71-5805

February 26, 2007  
E&L-006-07

**SUBJECT: SUBMITTAL FOR MODEL NO. CNS 3-55 PACKAGE**

Duratek, Inc. (Duratek) respectfully requests an amendment to the Certificate of Compliance for the Model No. CNS 3-55 Package. This amendment is in the form of a revision to Drawing No. MOD-124, VNDB Skid Assembly, to include tolerances for some dimensional measurements. These have been added to the drawing as Notes 6 and 7.

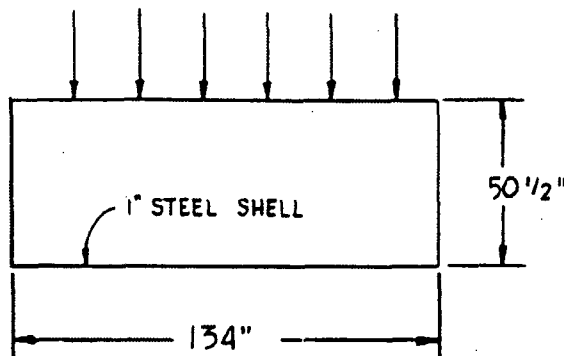
Tensile stress in the 8 in. x 1 in. strap is:

$$\sigma = \frac{P}{A} = \frac{234,500}{8 \times 1} = 29,312 \text{ psi}$$

$$\frac{36,000}{29,312} - 1 = \underline{0.23 \text{ M.S.}}$$
